#### **DEPARTMENT OF TRANSPORTATION**

# **Anthropomorphic Test Dummy; Occupant Crash Protection**

**AGENCY:** National Highway Traffic Safety Administration (NHTSA), DOT. **ACTION:** Interim final rule; request for

# FIGURE 20 FLEXION - TEST SET-UP SPECIFICATIONS

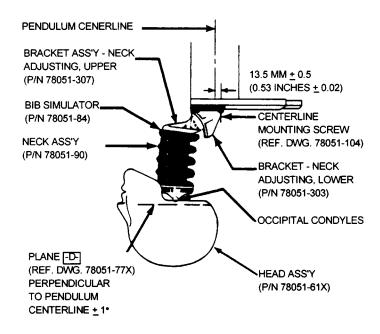
- (1) Flexion. (i) Plane D, referenced in Figure 20, shall rotate between 64 degrees and 78 degrees, which shall occur between 57 milliseconds (ms) and 64 ms from time zero. In first rebound, the rotation of Plane D shall cross 0 degrees between 113 ms and 128 ms.

- (ii) The moment measured by the six axis neck transducer (drawing C-1709, revision D) about the occipital condyles, referenced in Figure 20, shall be calculated by the following formula: Moment (lbs-ft) =  $My - 0.058 \times Fx$ , where My is the moment measured in lbs-ft by the "Y" axis moment sensor of the six axis neck transducer and Fx is the force measured in lbs by the "X" axis force sensor (Channel Class 600) of the six axis neck transducer. The moment shall have a maximum value between 65 lbs-ft and 80 lbs-ft occurring between 47m s and 58 ms, and the positive moment shall decay for the first time to 0 lb-ft between 97 ms and 107

# FIGURE 21 EXTENSION - TEST SET-UP SPECIFICATIONS

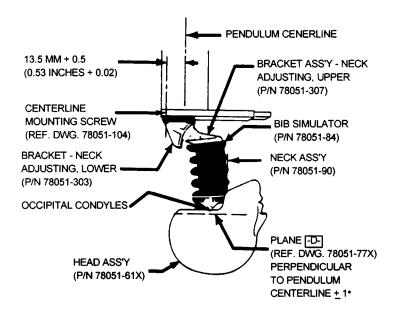
- (2) Extension. (i) Plane D, referenced in Figure 21, shall rotate between 81 degrees and 106 degrees, which shall occur between 72 ms and 82 ms from time zero. In first rebound, rotation of Plane D shall cross 0 degrees between 147 ms and 174 ms.

- (ii) The moment measured by the six axis neck transducer (drawing C-1709, revision D) about the occipital condyles,

referenced in Figure 21, shall be calculated by the following formula: Moment (lbs-ft) =  $My-0.058 \times Fx$ , where My is the moment measured in lbs-ft by the "Y" axis moment sensor of the six axis neck transducer and Fx is the force measured in lbs by the "X" axis force sensor (Channel Class 600) of the six axis neck transducer. The moment shall have a maximum value between—39 lbs-ft and –59 lbs-ft, occurring between 65 ms and 79 ms, and the negative moment shall decay for the first time to 0 lb-ft between 120 ms and 148 ms.
